RE: **SUBMITTAL OF TEST PLOT DRAWING AND PROCEDURES, PACIFICORP, DES  
BEE DOVE MINE, ACT/015/017 #2**

# DES BEE DOVE TEST PLOT - 1992

## DES BEE DOVE TEST PLOTS - 1992

# FIGURE 2

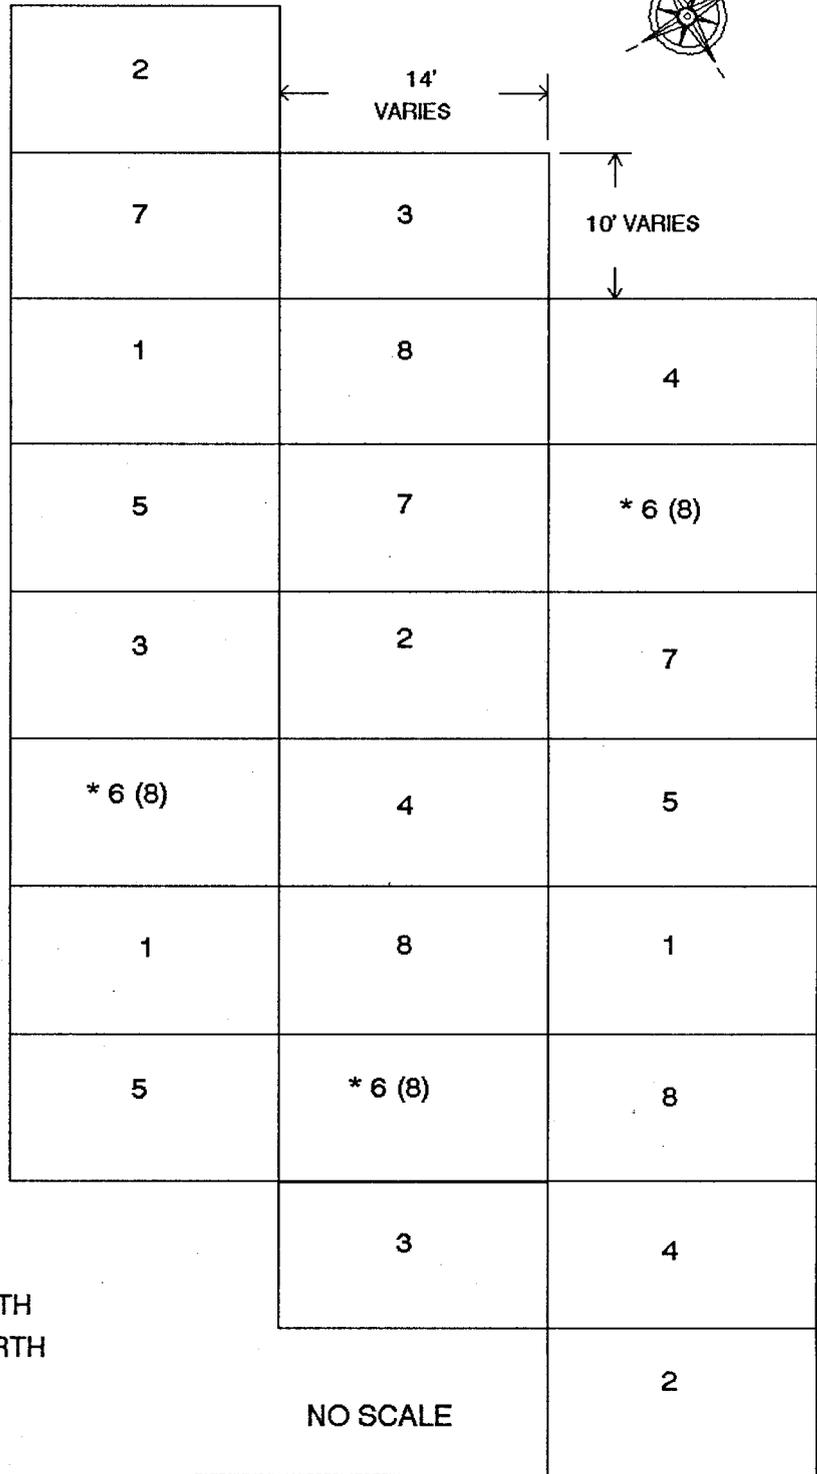
The installation of the test plots was completed on November 9, 1992. The original Test Plot Plan - 1992, submitted to the Division on 6-12-92, was followed with the exception of the deletion of the sewage sludge admixture and the treatment of 1,000 lbs/acre to all "Live Earth" admixture plots instead of the varied 1,200 to 800 lbs/acre. These changes are reflected in the added Figure 2 "as-built" drawing and the Plot Installation 11-9-92.

- Approximately 1 cubic yard of Coal Waste material was raked evenly over plots 2 and 5.
- Approximately 1 cubic yard of Rocky Soil was raked evenly over plots 1 and 4.
- 10 lbs. (1,000 lbs/acre) of "Live Earth" was placed on plots 3,4 and 5 by a broadcasting with a hurricane spreader.
- The Sewage Sludge was not applied to plot 6 because of no application approval from the Divisions within the Department of Environmental Quality.

\* PLOT #6 WERE NOT APPROVED BY STATE AGENCIES. THESE PLOTS WERE TREATED WITH TREATMENT #8 ONLY
